ACTION MEMORANDUM

REMOVAL OF SOILS CONTAMINATED WITH POLYCHLORINATED BIPHENYLS (PCBs) SITE 1 - PRIVET ROAD COMPOUND

Prepared For
NAVAL AIR STATION JOINT RESERVE BASE
WILLOW GROVE, PENNSYLVANIA 19090-5010

ATTACHMENT B
RESPONSES TO REGULATORY COMMENTS ON
DRAFT ACTION MEMORANDUM

DRAWN BY D. PERRY	DATE 11-FEB-99	Tetra Tech NUS, Inc.	CONTRACT NUMBER 5466	OWNER NO. ---
CHECKED BY	DATE		APPROVED BY	DATE
COST/SCHEDULE-AREA		IMMUNO ASSAY SAMPLE LOCATIONS SITE 1 - PRIVET ROAD NASJRB WILLOW GROVE	APPROVED BY	DATE
SCALE			DRAWING NO.	REV
AS NOTED			FIGURE 2	0

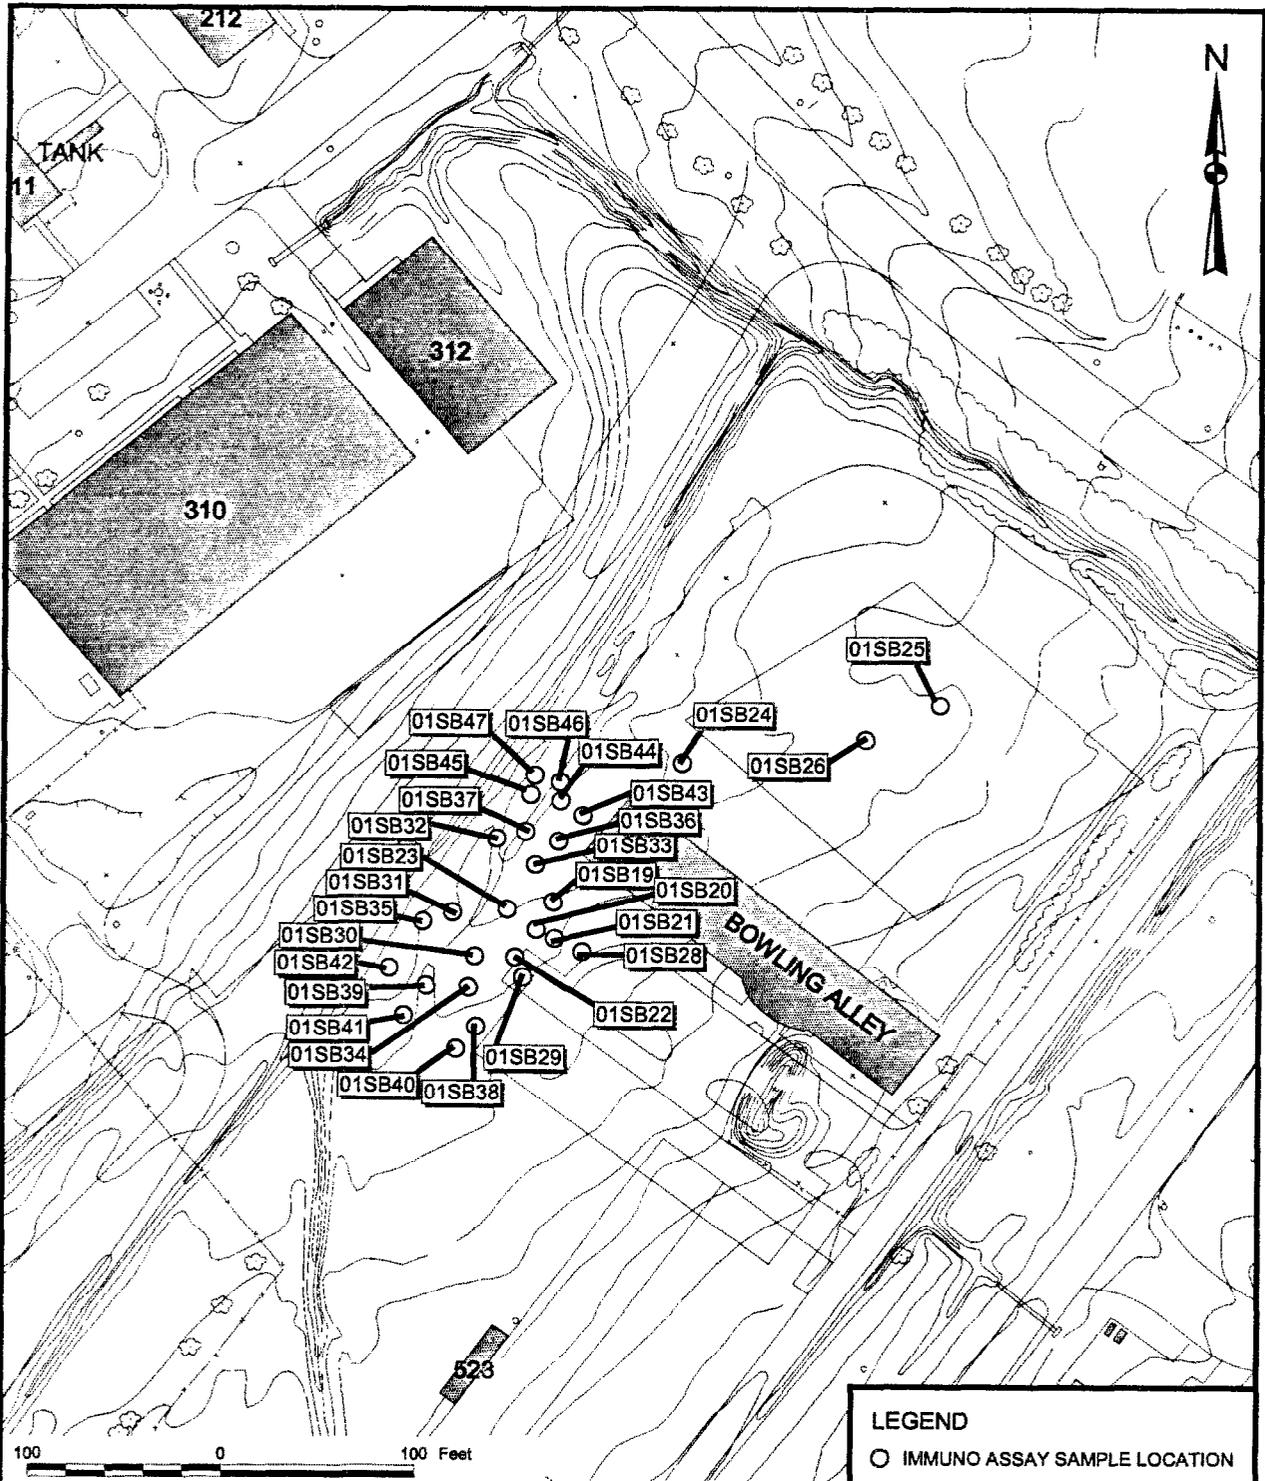
- 1) Attachments 1, 2 and 3 (or Figures 1, 2 and 3) referred to on Page 3 of the Removal Action Memo.
- 2) Figure 1 referred to in the Foster Wheeler Workplan of 9/15/98
- 3) The following info referred to on page 4-9 of the Draft Phase II RI of 4/98:
 - Map with the 28 locations where surface soil samples were collected for TCL and/or PCB immunoassay analysis (Figure 4-1 does not provide these locations as indicated)
 - Map indicating any subsurface soil sample locations not provided on the map referenced directly above

- **Figure 1** shows the site location of the Privet Road Compound
- **Figure 2** shows all of the locations where immunoassay test kits were used during the Phase 2 RI to screen the extent of PCB contamination

DRAWN BY D. PERRY	DATE 10-FEB-98	 Tetra Tech NUS, Inc.	CONTRACT NUMBER 5466	OWNER NO ---
CHECKED BY	DATE		APPROVED BY	DATE
COST/SCHEDULE-AREA		PCB RANGES SITE 1 - PRIVET ROAD NASJRB WILLOW GROVE	APPROVED BY	DATE
SCALE AS NOTED			DRAWING NO. FIGURE 6	REV 0

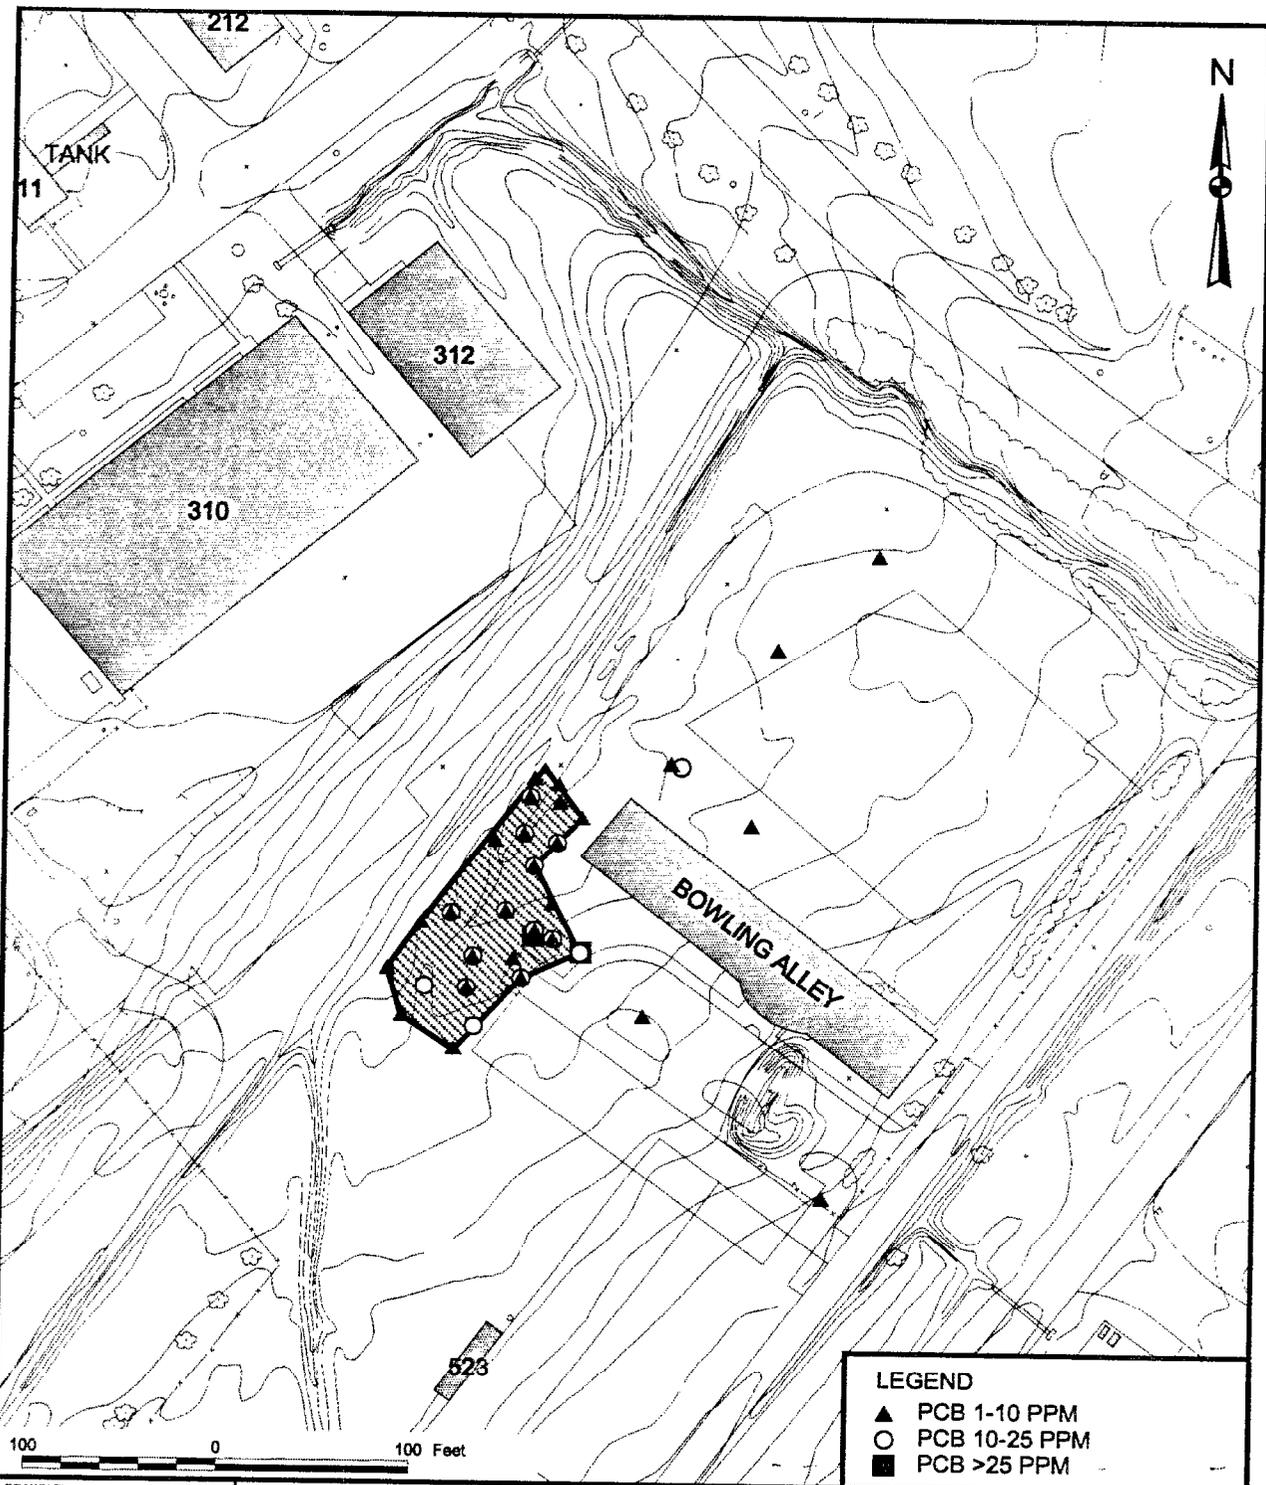
FOLLOW-UP COMMENT: Please also provide any available information regarding the target "cleanup levels" and the basis/rationale for the levels; (Neither the Action Memo nor the Workplan provide this info).

- **Figure 6** shows the locations and ranges of PCB detections, both from immunoassay testing and laboratory analysis.

As stated above, Figure 6 shows the planned areas that will be excavated to address PCB contamination in Site 1 soils. For the soils located to the south and west of the Bowling Alley, a rectangular area will be excavated to a depth equal to the deepest PCB detection and will fully encompass the area where the PCB detections are the most concentrated. After excavation is completed, confirmation sampling will be conducted in accordance with PADEP's ACT II guidance (i.e. 12 confirmation samples since volume of excavated soils are less than 3000 cu. yds. but greater than 125 cu. yds.).

There are also seven (7) other samples shown at six (6) separate spot locations outside of the main excavation area where PCBs were detected at a concentration in excess of 1 ppm. These 6 locations will also be excavated to the appropriate depths and confirmation samples taken from within each excavated area which is expected to be at least 4 feet x 4 feet in area. Confirmation samples taken from these locations will consist of 2 sidewall samples and 2 samples from the bottom of each 4 x 4 box. This translates into a total of 24 confirmation samples for the six separate spot locations. It is expected that the cubic yardage generated for these 6 locations, in total, will be in excess of 125 cu. yd. but less than 3,000 cu. yds., therefore requiring a minimum of 12 confirmation samples, in accordance with PADEP's ACT II guidance.
